LAX/Community Noise Roundtable

Work Program A7 – Review/Consider
Monterey Park’s Recommendations
Regarding Aircraft Overflights

November 9, 2016

North Downwind RNP

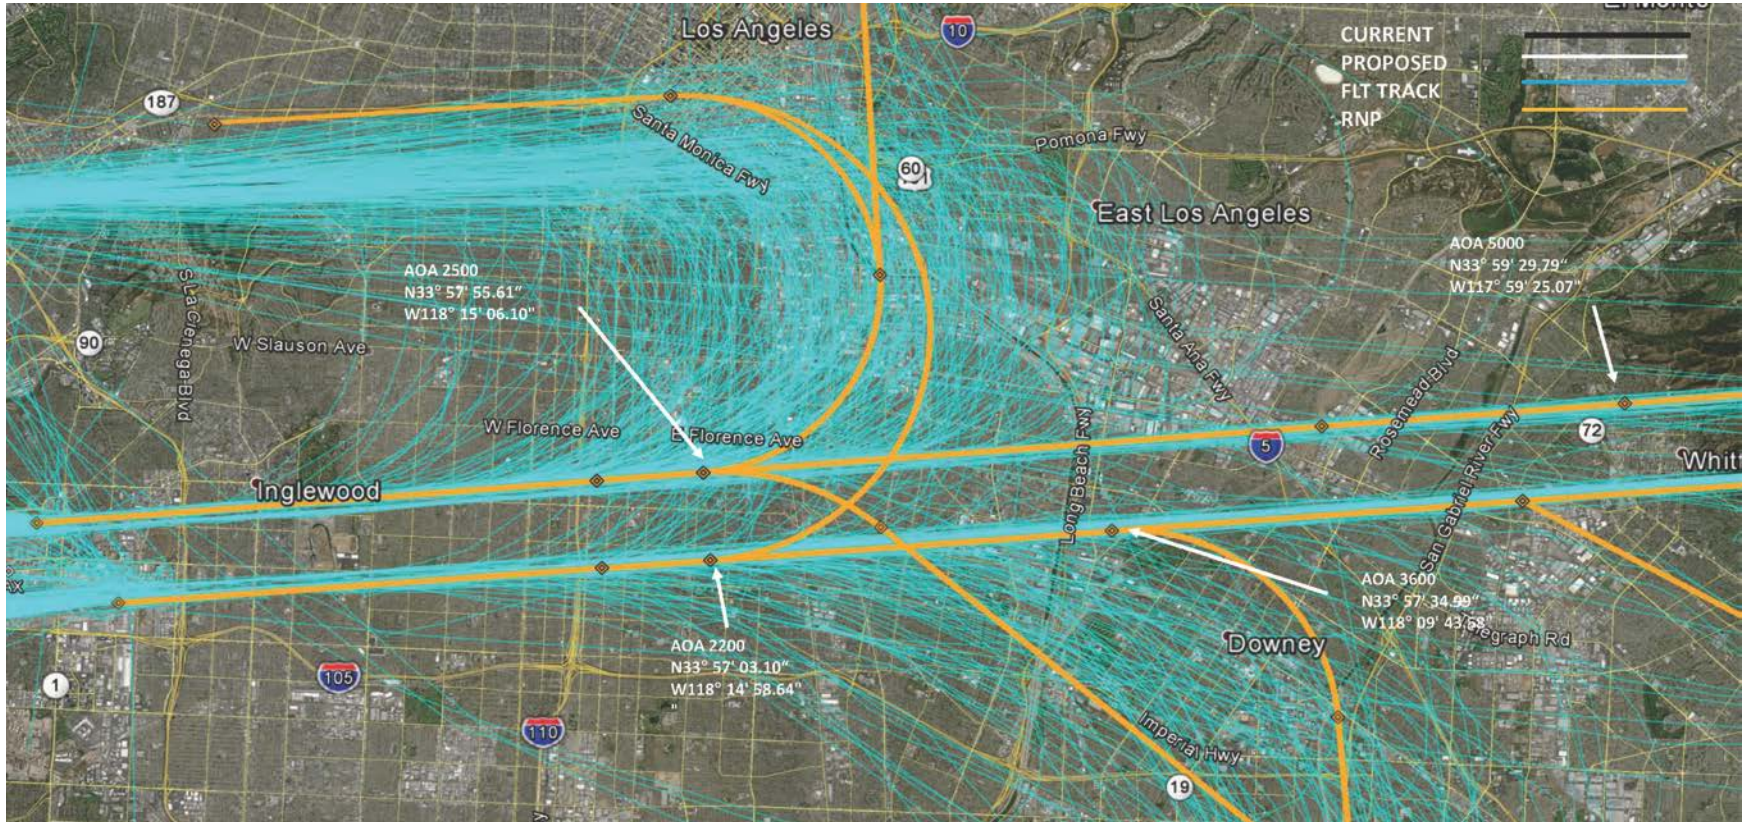
7. Hold regular workshops and collaborate with FAA (both LAX Tower & TRACON) to incorporate the 1999 Monterey Park recommendations into the current procedures or the draft Metroplex Project implementation plan

- The LAX Tower attends every Roundtable meeting and staff from the SoCal TRACON (in San Diego) attend Roundtable meetings upon request
- FAA considered the Roundtable's recommendations to address concerns associated with the EDA in the SoCal Metroplex project
 - The North Downwind RNP may provide noise benefits to Monterey Park after the procedure is published and as aircraft are equipped and pilots are trained to fly it
- It may be prudent to assess the benefits/drawbacks of the new Metroplex procedures for all Roundtable communities under the North Downwind Arrival and Extended Downwind Approach for several months after implementation, then share the Roundtable's feedback with FAA

- The North Downwind RNP arrival procedures during west flow may partially reduce overflights of Monterey Park;
- Approximately 40 percent of the aircraft currently using LAX can fly the RNP; that number will increase over time as more aircraft become equipped
- Concentrates the base leg turn over primarily commercial land uses between the 110 and 710 freeways
- Aircraft may still be vectored further to the east when safety requires it or when aircraft are not equipped to fly the RNP
